Subject: CREAK NOISE FROM REAR OF VEHICLE WHEN CLUTCH IS ENGAGED QUICKLY OR VEHICLE ACCELERATES/DECELERATES RAPIDLY	Bulletin No: 05-006/16
	Last Issued: 08/23/2016

2016 MX-5 vehicles with VINs lower than JM1ND*****106639 (produced before October 5, 2015)

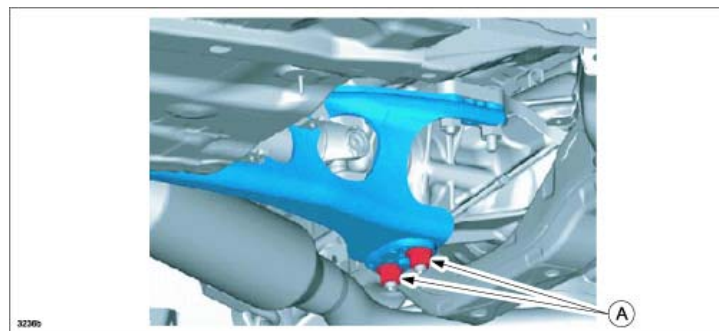
Some vehicles may exhibit a creak noise from around the rear differential when the clutch is engaged quickly or the vehicle accelerates/decelerates rapidly. This is caused by a stick-slip noise occurring at the contact surface between the power plant frame (PPF) (A) and the rear differential. To eliminate this concern, the tightening torque of the stud bolts and nuts has been increased.

1. Verify customer concern.
2. Tighten the stud bolts and nuts securing the power plant frame (PPF) to the rear differential.
 - a. Place the vehicle on a lift.
 - b. Loosen the two mounting nuts (A) of the PPF until they are not touching the frame.

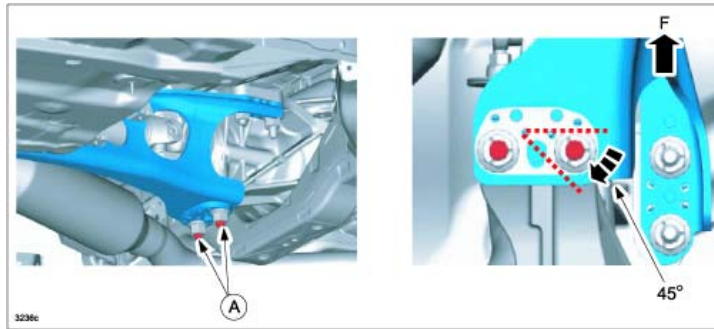
c. Tighten the two stud bolts (A) of the PPF to 45 degrees.

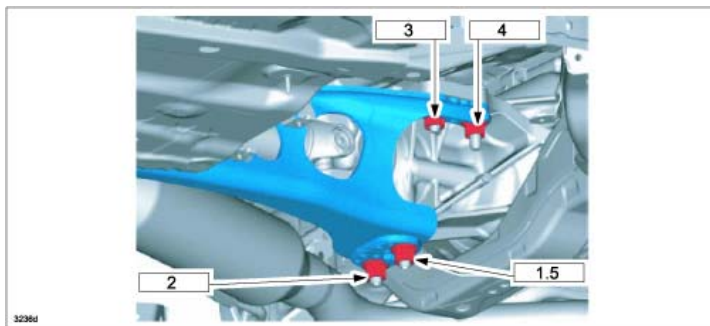
d. Tighten the four mounting nuts of the PPF in the numbered sequence as shown.

Tightening torque: 134-148 ft lb (182-200 Nm, 18.6-20.4 kgfm)
